KARACHI WATER & SEWERAGE BOARD

CONSTRUCTION OF NEW 100 MGD PUMP HOUSE
(Equipped with M&E Pumping Machineries)
at Dhabeji

Bid Evaluation Report

TECHNICAL EVALUATION REPORT

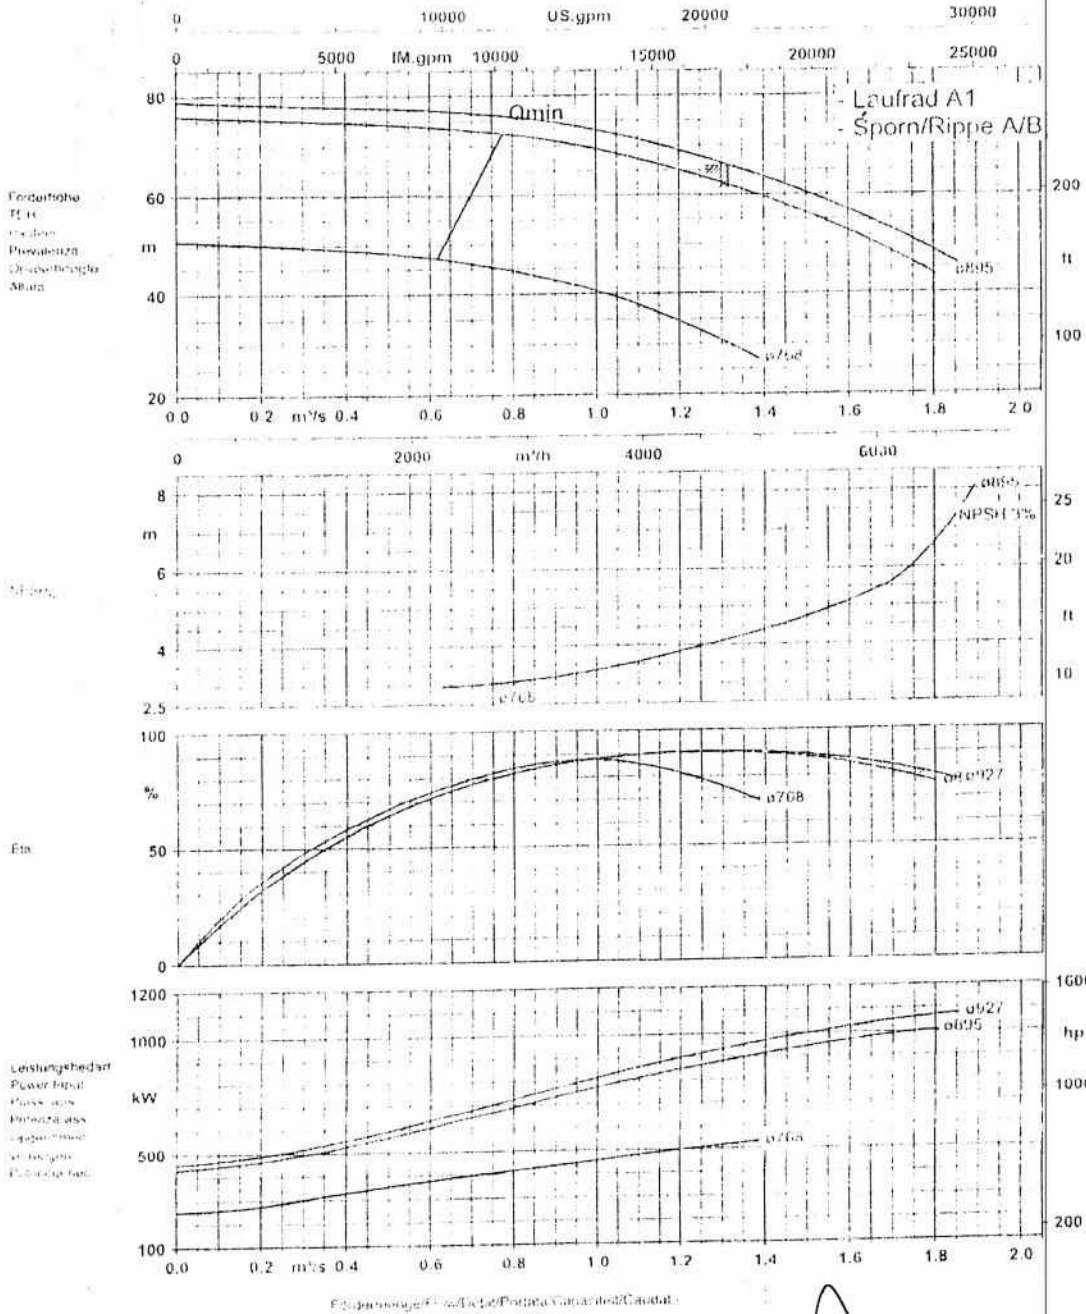
Calculation of available NPSH is not submitted by the Bidder and needs to be submitted by contractor (KSB). However, available NPSH is estimated 8.5 m by M/s. Osmani & Co. Pvt. Ltd. in their report and calculation is shown below. This needs to be verified during detailed design by the bidder and was agreed upon by the bidder in a meeting on 30th August 2016 at KW&SB office.

Figure 6-3: Projected screen chamber

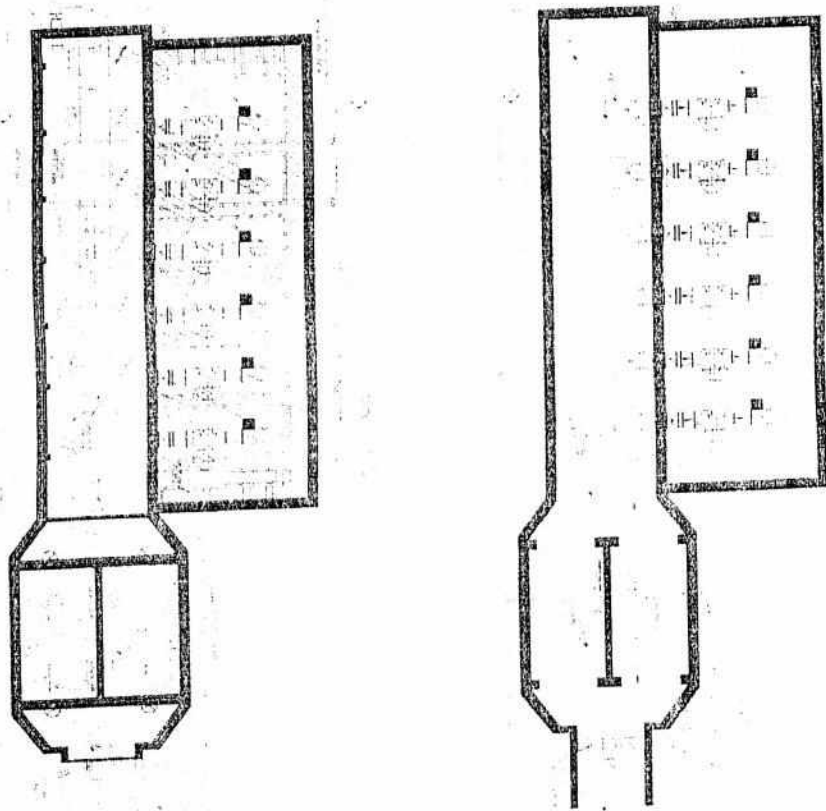
The Consultant, in his report stated that the Screen Chamber footprint as submitted by the bidder extends westward on the existing road. The bidder agreed that the footprint of the screen chamber shall be reevaluated during the detailed design phase of the project. The projected screen chamber as shown in KWSB – OH – 1 – 01 attached as Figure 6-3 below.
